Re: St. Lucie Unit 1
Docket No. 50-335
FPL Response to Request for Additional Information for
10 CFR 50 Appendix R K1 Exemption Clarification/Request

FPL Response to NRC RAI Dated March 5, 2002

**FIRE HAZARD ASSESSMENT OF
EXPOSURE TO SAFE SHUTDOWN RACEWAYS, ST. LUCIE UNIT 1**

Figure 3 – Schematic diagram of the SA cable tray array at Reference Point 2305

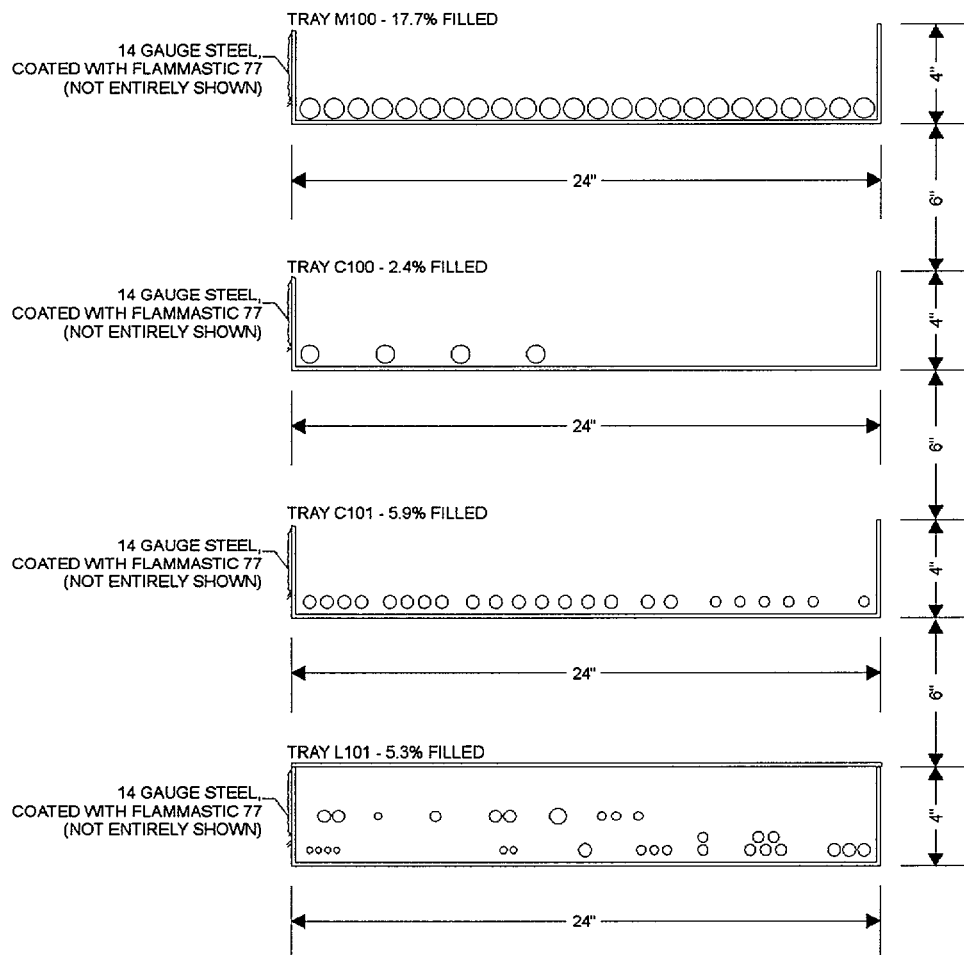
Figure 3 shows flamemastic coating only on the cable trays. Were the individual cables completely coated also?

Section 3.1 of Attachment 2 was revised to be more specific.

Figure 6. – Side View of Horizontal/Vertical Cable Tray Configuration
around Reference Point 2307 (not to scale)

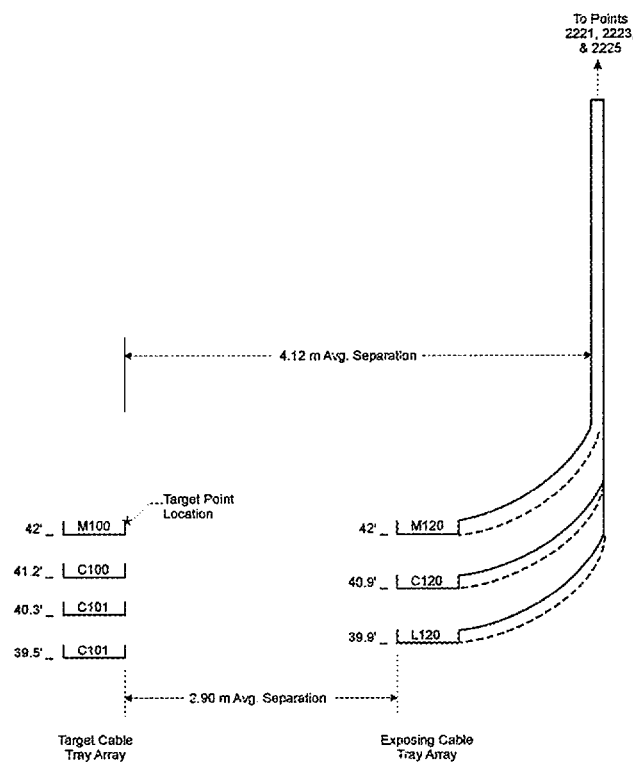
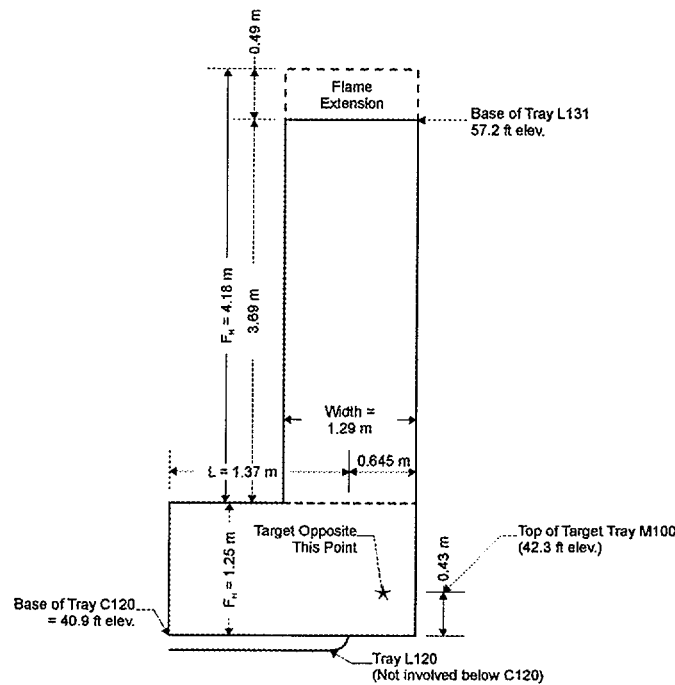
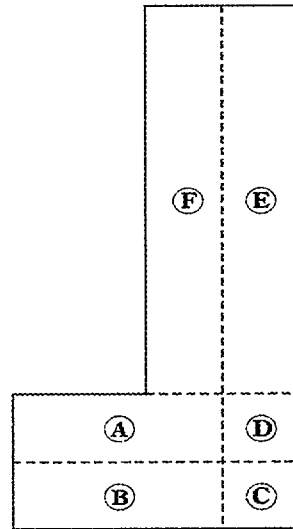
A stacked vertical tray configuration was modeled, but the drawing on page 1 of Appendix A of Attachment 2 shows the cable trays in a side by side configuration. The vertical height is over nine feet and each tray is two feet wide giving the three trays a 54 ft² (5 m²) surface area. The report models a 15-inch wide vertical fire at some undefined height, which doesn't seem to portray the actual configuration. In addition, wouldn't the fire grow horizontally on the lower and upper elevations at the same time? Justify in more depth the vertical cable fire scenario.

Section 8.2.1 of Attachment 2 was revised to address the concerns identified above. The NRC question refers to the vertical cable tray run near reference point 2307. The geometry of this horizontal to vertical cable array transition was modeled more accurately and evaluated to determine whether it formed an alternative MEFS. The target cable location was the top tray of the horizontal running cable array, which consists of Trays M100, C100 and C101. This target is exposed simultaneously to nmb a burning length of horizontal and vertical cable tray array. The burning horizontal and vertical array is comprised of trays M120, C120 and L120. Tray L120 in the horizontal array is covered with sheet metal tray covers and does not contribute to the exposure fire in the horizontal position, which is consistent with the MEFS assumptions. All three trays in the vertical configuration are covered with sheet metal tray covers and if involved in a fire would not be expected to substantially contribute to the heat flux to the target. However for purposes of performing a screening calculation the vertical trays are assumed to burn as if they were uncovered and contribute to the flame radiation to the target. The calculated target flux in this arrangement is 3.94 kW/m². The calculated target flux for the MEFS for the "horizontal only" case is 3.81 kW/m². These are effectively the same results even assuming all three covered vertical trays contribute as if they were open. Clearly these covered trays would not substantially contribute to the heat flux to the target, hence we conclude that the "horizontal only" case is the MEFS.
